Access Compliance Report

Public Rights-of-Way

(Curb Ramps)

Intersection ID: 18189	Main Street: S_WENDOVER_RD	Cross Street: FOREST_DR	Location: SE
ADA ID: 74E9422B0B27	Ramp Type: PerpDiag	Initial Pass/Fail: Fail	Overall Compliance: No
Severity Score: 12.5			
Codes/Mitigation Info/Possible Solution		Field Measurements/Component Compliance

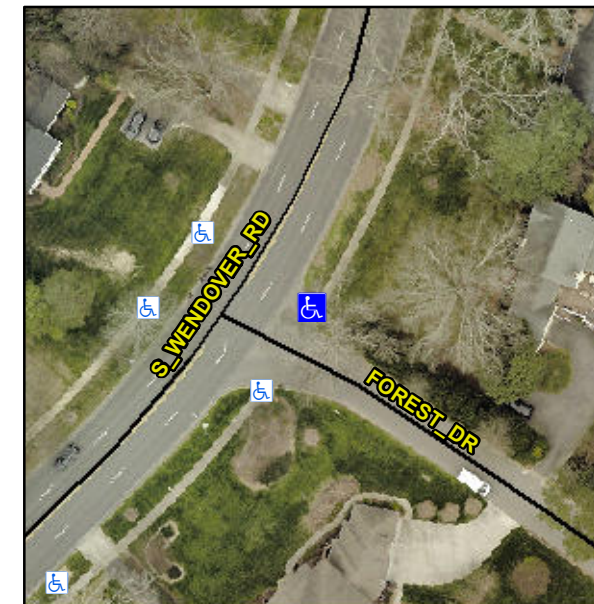
Not Found, R304.2.2

Compliance	Description	Data	Compliance	Description	Data
N/A	Ramp Length (in)	62.0	No	Ramp Slope (%)	8.4
Yes	Ramp Width (in)	48.0	Yes	Ramp XSlope (%)	0.8
N/A	Flare Type LT	N/A	N/A	Flare Type RT	N/A
N/A	Flare Slope LT (%)	N/A	N/A	Flare Slope RT (%)	N/A
N/A	Flare Traversable LT?	N/A	N/A	Flare Traversable RT?	N/A
N/A	Landing Length (in)	N/A	N/A	DWS Provided?	N/A
N/A	Landing Width (in)	N/A	N/A	DWS Contrast?	N/A
N/A	Landing Slope (%)	N/A	N/A	DWS Length (in)	N/A
N/A	Landing X Slope (%)	N/A	N/A	DWS Full Width?	N/A
N/A	Landing Curb? (Y/N)	N/A	N/A	DWS Offset (in)	N/A
N/A	Shared Landing?	N/A			
N/A	Gutter Ponding?	N/A	N/A	Gutter Slope (%)	N/A
N/A	Gutter Lip Ht (in)	N/A	N/A	Gutter X Slope (%)	N/A
N/A	Painted X Walk1?	No	N/A	Painted X Walk2?	No
	X Walk 1 Direction	To NE		X Walk 2 Direction	To SW
N/A	X Walk 1 Width (in)	N/A	N/A	X Walk 2 Width (in)	N/A
	X Walk 1 Slope (%)	7.7		X Walk 2 Slope (%)	5.2
	X Walk 1 X Slope (%)	2.4		X Walk 2 X Slope (%)	7.6

Remove & Replace Curb Ramp With Two New Directional Ramps or Equivalent.
